Lincoln Colony Apartments Project

Soil and Foundation Evaluation Report, March 2021

Subject: Clarification Letter
Proposed Apartment Building
914 West Lincoln Avenue, Anaheim, California

**Subject: Soil and Foundation Evaluation Report Update
Proposed Apartment Building
898, 900 and 914 West Lincoln Avenue, Anaheim, California**

GEOTECHNICAL PLAN	
FIGURE-A-1-1	PROJECT NO.:A-7075-19
DATE :11/21/2019	SCALE: 1"=20'

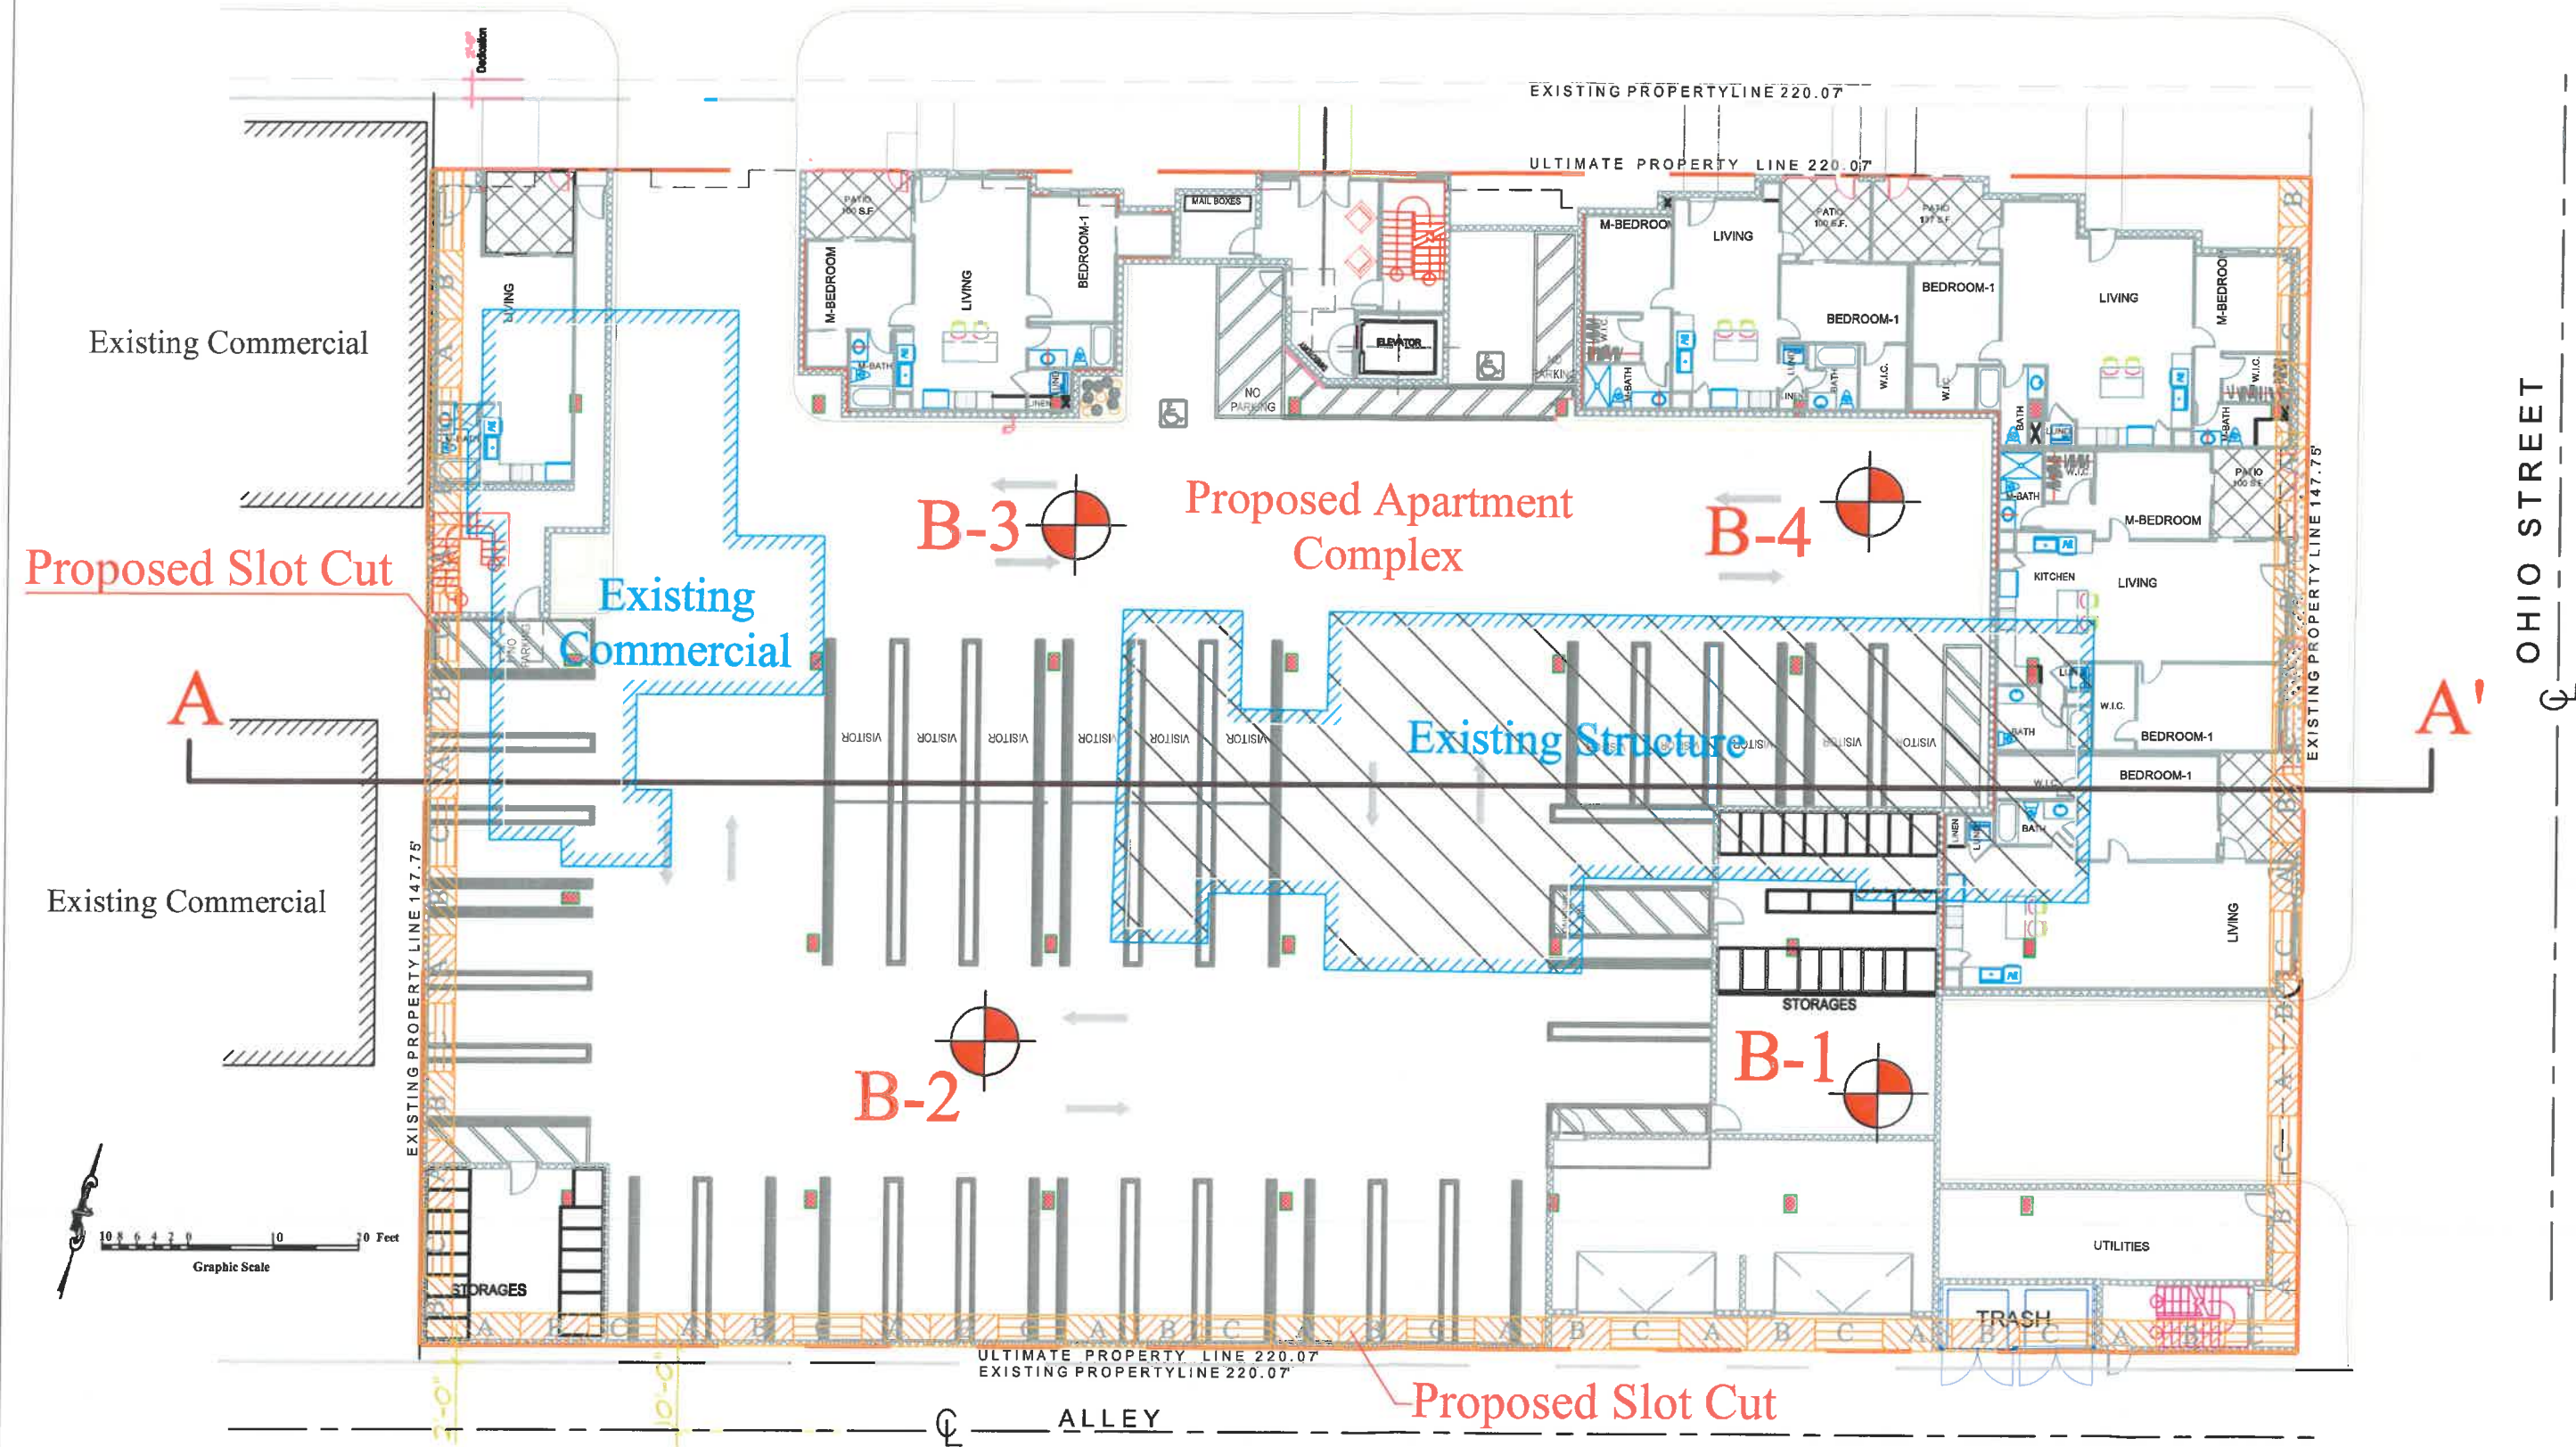
3. Referring to Geotechnical Plan (Figure A-1-1)
Please discuss and provide a procedure for slot cutting delineated along the south and westerly property line. Moreover, discuss the adverse impact of the proposed development during and after the construction on adjacent properties.
